FLRD #2 LLC

PHASE II REGIONAL WATER IMPROVEMENTS 0.26 MG POTABLE WATER TANK

PPR V_1 redlines.pdf Markup Summary

FLRD #2, LLC.
PHASE II REGIONAL WATER IMPROVEMENTS
0.26 MG POTABLE WATER TANK
DETAILS

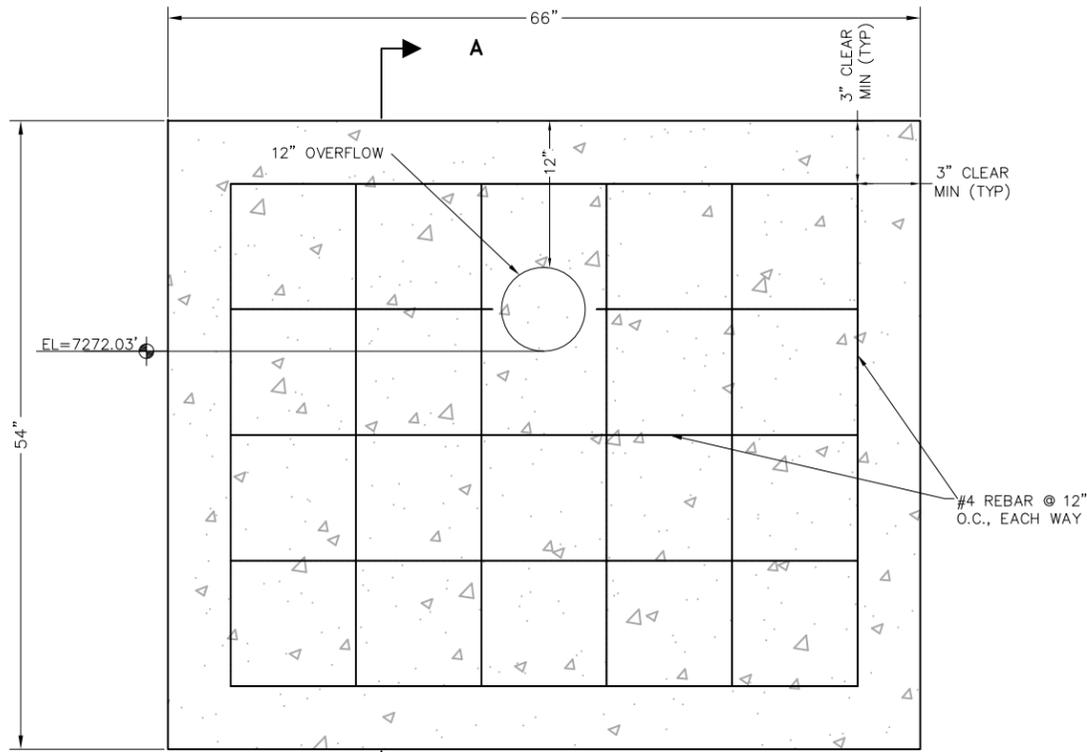
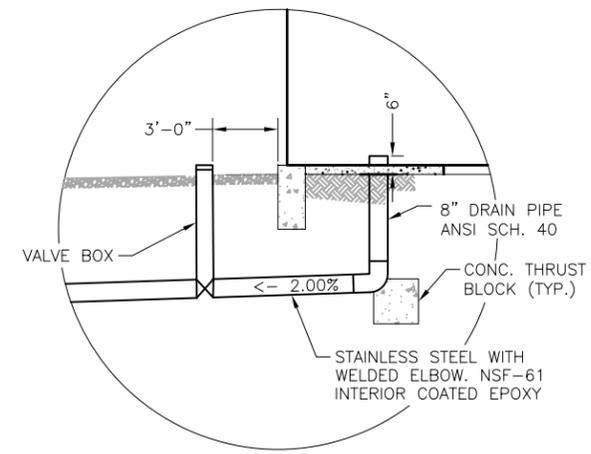
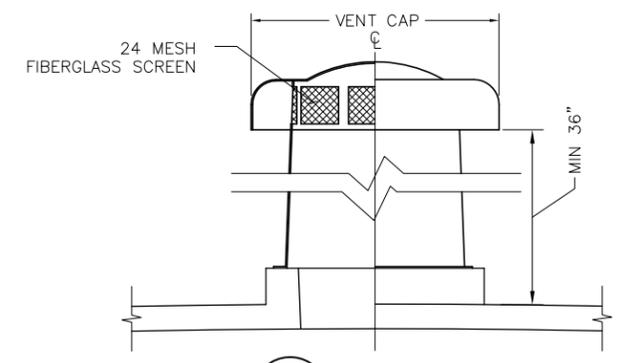
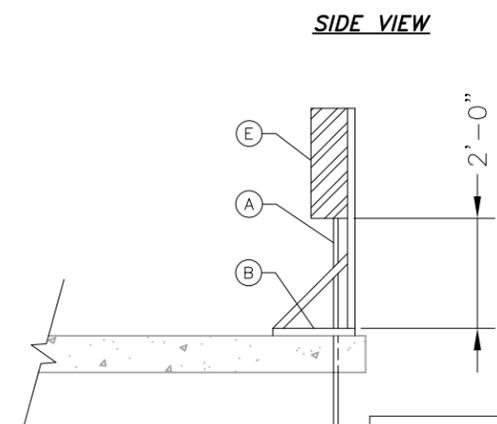
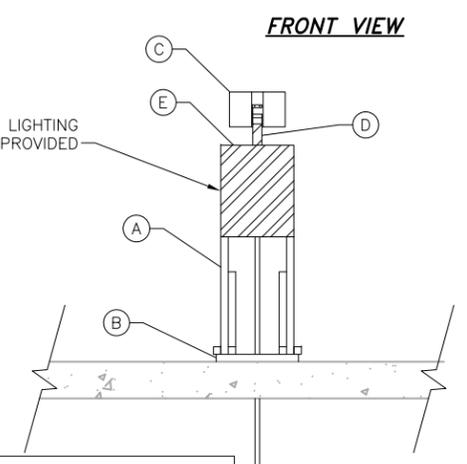
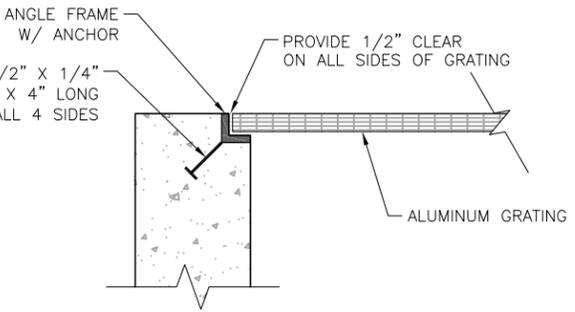
what kind of detail is sheet?

C7
SHEET 10 OF 11

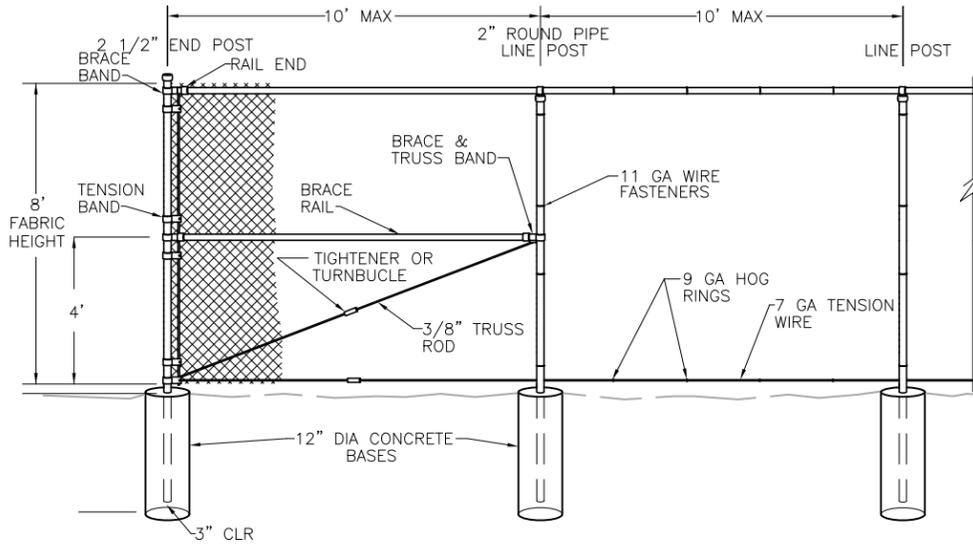
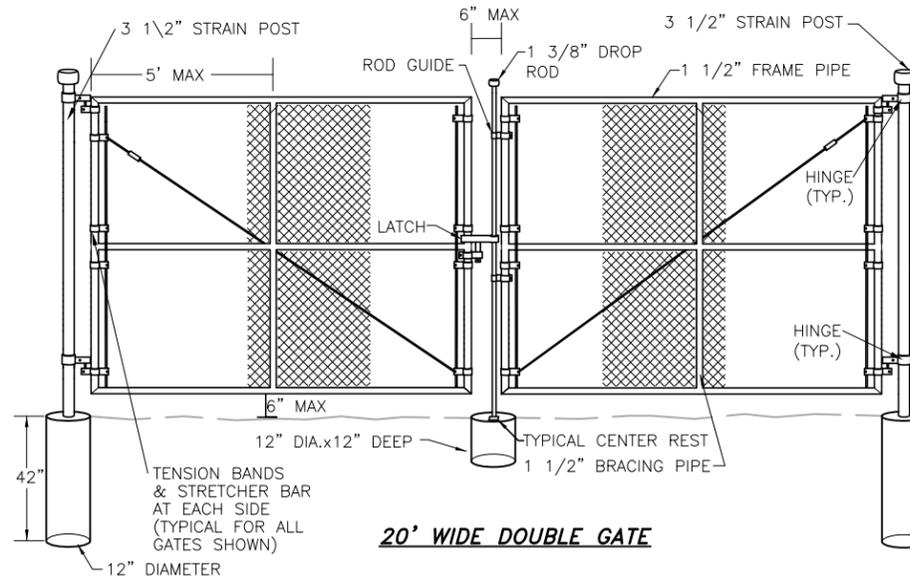
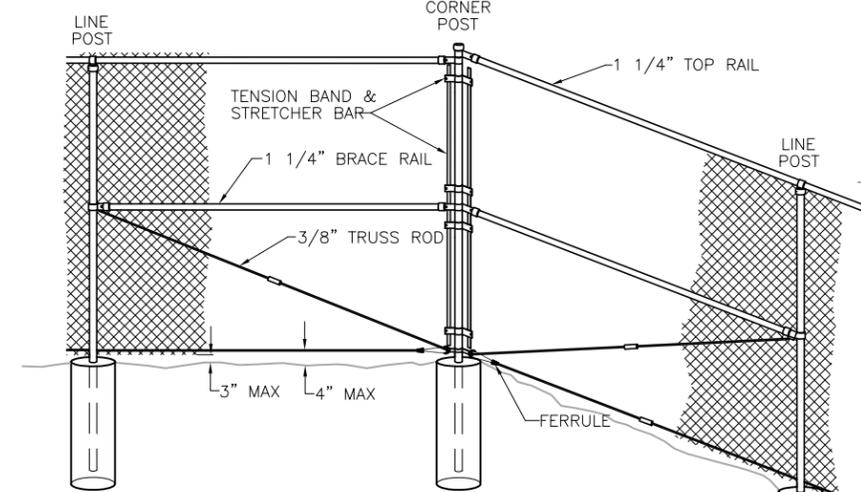
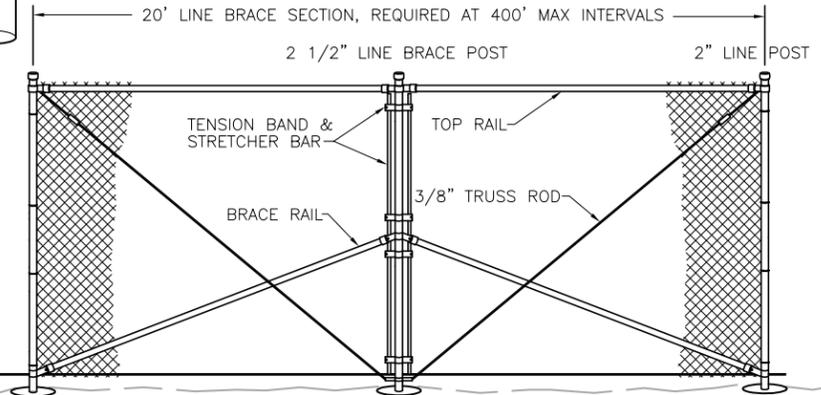
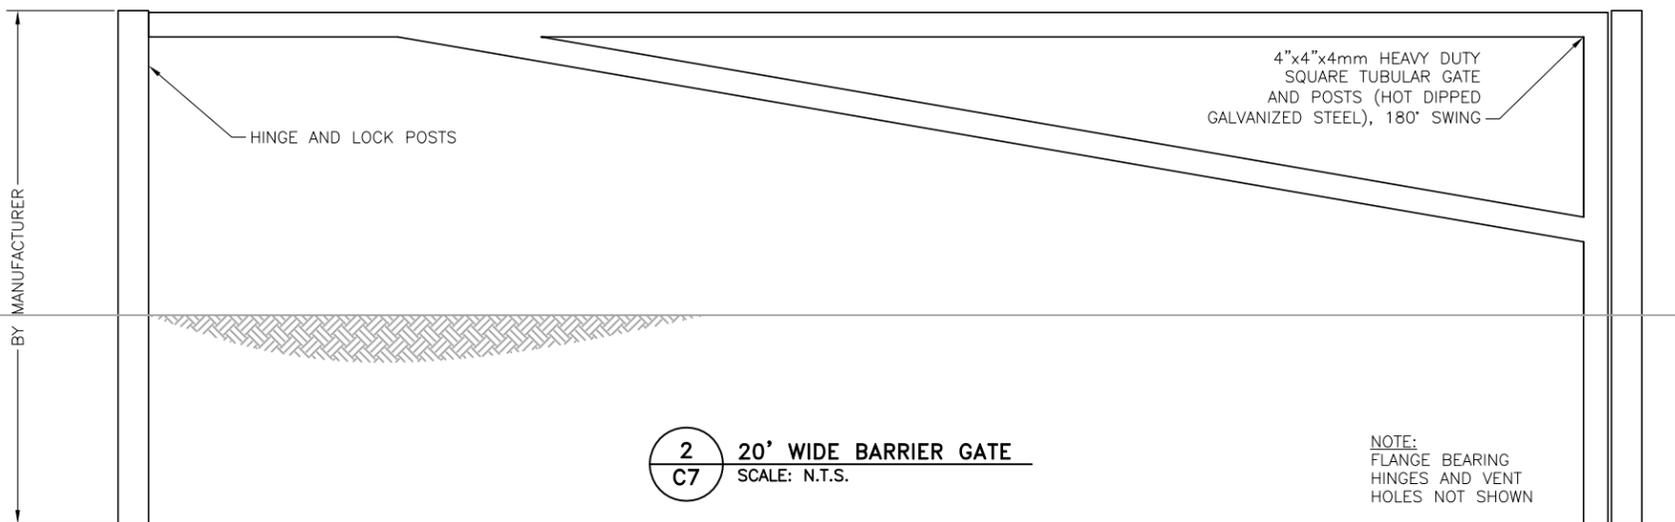
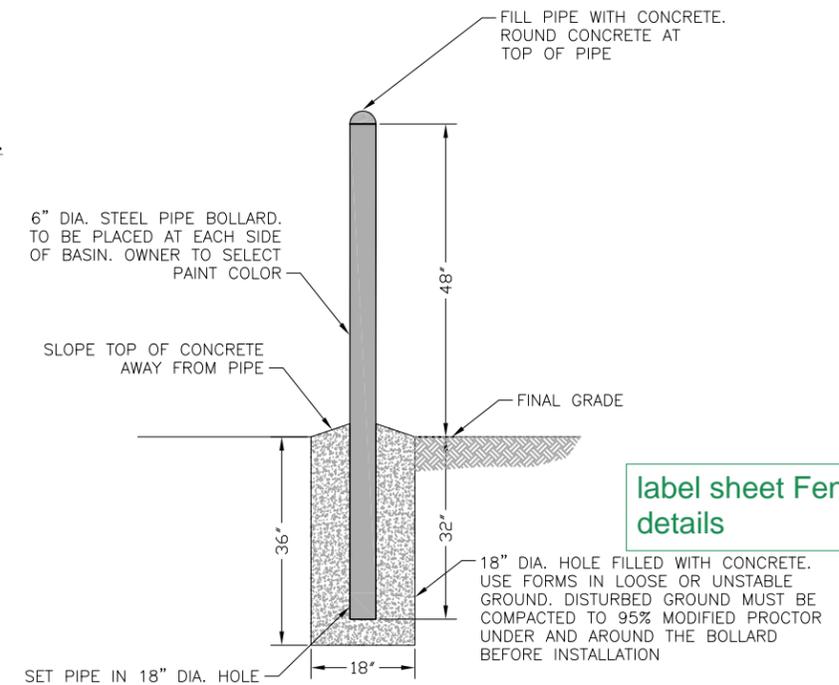
label sheet Fence details
